Site Audit

2 Christina Road, Villawood

for Orica Australia Pty Ltd
March 2012

J1196.14R-rev0

Figure 4
Locations of Dissolved Phase Plumes
and Identified Source Zones (ISZ)

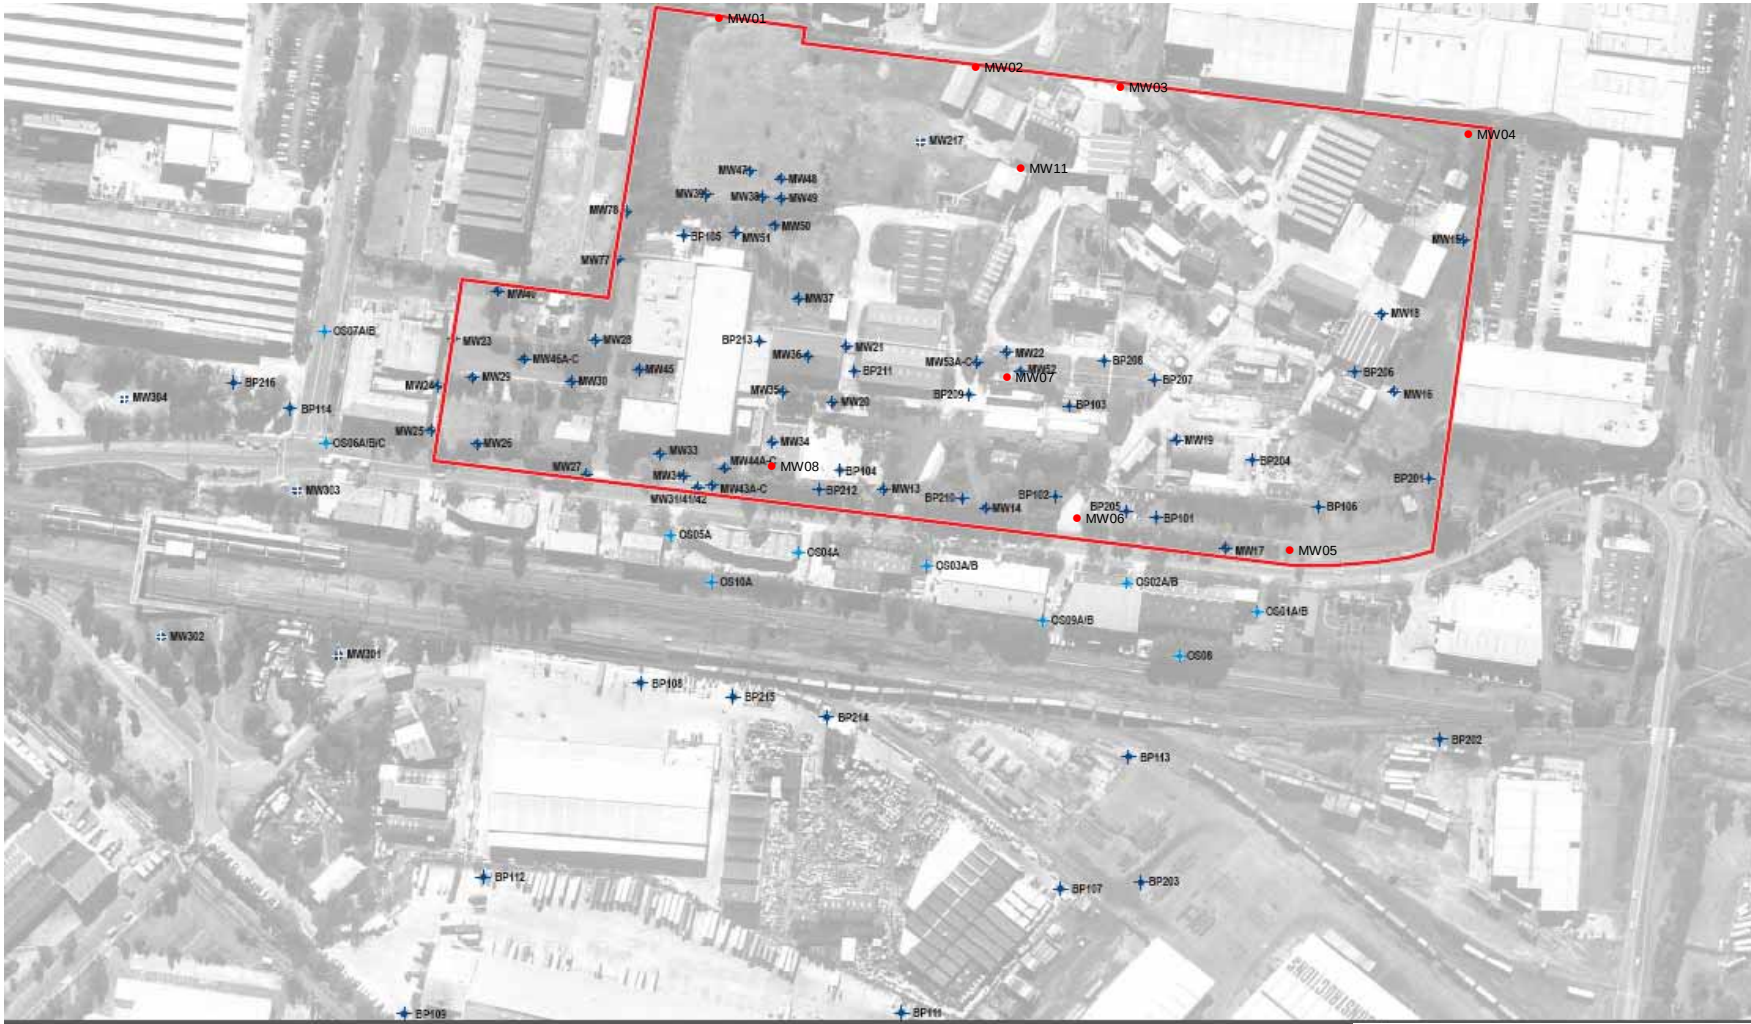
The Auditor considers that the data support CH2M HILL's conclusions, but the extent of the remedial area may be different than indicated on CH2M HILL's Figure 4, and will need to be defined by validation sampling to be carried out as part of the overall site remediation works.
